From: Terry, Tomeka
Sent: Monday, July 16, 2012 1:41 PM
To: VictoriaESP Resource
Subject: FW: Courtesy copy of Exelon Letter NP-12-0028 - Response to ER RAI Letters No.12 and No.13
Attachments: NP-12-0028 - Responses to ER RAI Letters No.12 and No.13.pdf

NP-12-0028
July 13, 2012

Subject: Exelon Nuclear Texas Holdings, LLC
Victoria County Station
Early Site Permit Application
Environmental Report – Responses to ER RAI Letters No.12 and No.13
Docket No. 52-042

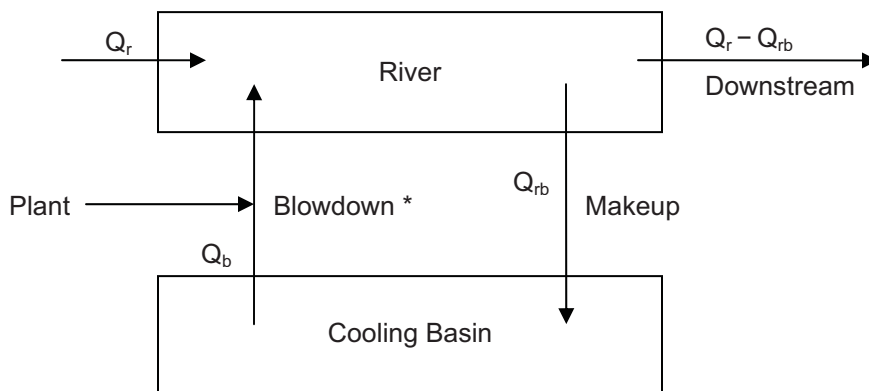
RW 3.5.-2 - ESRP Section 3.5 directs the staff to review the applicant's design of radioactive waste management and effluent control systems presented in the Environmental Report (ER). The blowdown discharge location for liquid effluent release is upstream of the raw water makeup intake structure (ER Figure 2.3.1-1). The releases upstream have a potential to get in the cooling basin through the raw water makeup system downstream. This mechanism could result in contaminating the cooling basin. ESRP Section 5.4.2 directs the staff to review the applicant's evaluation of doses due to radioactive gaseous and liquid effluent discharges presented in the ER. Licensees are responsible for evaluating any new exposure pathways and the resultant radiological hazards associated with the return of radioactive material to the operating facility and its subsequent discharge to the environment. As described in Regulatory Guide 1.109, "Calculation of Annual Doses to Man from Routine Releases of Reactor Effluents for the Purpose of Evaluating Compliance with 10 CFR Part 50, Appendix I, "Revision 1, issued October 1977, licensees must evaluate any new exposure pathways to members of the public that contribute 10 percent or more of the total effluent dose and include these dose assessments in their demonstration of compliance with Appendix I to 10 CFR Part 50 Agencywide Documents Access and Management System at Accession No. ML072120368. Provide an evaluation of the potential radioactivity buildup concentration (pCi/L) in the cooling basin from the operation of proposed VCS units. Additionally, based on the radioactivity buildup concentration in the cooling basin, provide estimate of dose impacts to different receptors.

Liquid effluent from the proposed facility is to be discharged into the Guadalupe River via the cooling basin blowdown line. Downstream of the discharge point, a fraction of the river water is diverted to the plant as makeup for the cooling basin. As indicated in Regulatory Guide 1.113, for large water volumes with small blowdown rates, the concentrations of long-lived isotopes may build up over a period of several years [Ref 1, Sheet 37].

* Q_b is negligible compared to Q_r

- A = Activity in river (μCi)
- P = Effluent activity from plant, assumed to be released directly into river (μCi/sec)
- λ = Rate of activity removal from river (sec⁻¹)
- t = Time (sec)

For a long-lived isotope such as tritium, the decay term may be neglected, with λ simply becoming Q/V and Equation 2 reducing to the following [Ref 1, Sheet 26], with subscript r denoting the river:

If the cooling basin is the control volume, the concentration of a long-lived isotope in the cooling basin may be estimated by using a modified version of Equation 3, considering the activity in the river to be the production term for the cooling basin.

Equation 4 indicates that the concentration in the cooling basin may be conservatively estimated by multiplying the concentration in the river by the ratio of makeup rate to removal rate. The normal flow rates in the cooling basin are as follows, conservatively neglecting precipitation and losses via cooling towers [ER Figure 3.3-2]:

The maximum instantaneous makeup water flow from the river to the cooling basin is 97,396 gpm [ER Figure 3.3-2] or 217 cfs. Based on daily statistics from 1935 to 2008, the mean river flow rate is 2001 cfs [Reference 2]. Therefore, approximately 11% of the historical mean river flow may be diverted to the cooling basin, where there is potential for concentration buildup before being returned to the river via the blowdown pathway.

It is concluded that the impact of cooling basin recirculation on long-lived isotopes in the river and the resulting doses at liquid effluent receptors is negligible in light of the conservatism in the assumed river flow rate. Table 5.4-1 will be revised to clarify this conservatism. Furthermore, the liquid effluent source terms are based on a conservative composite of multiple reactor designs.
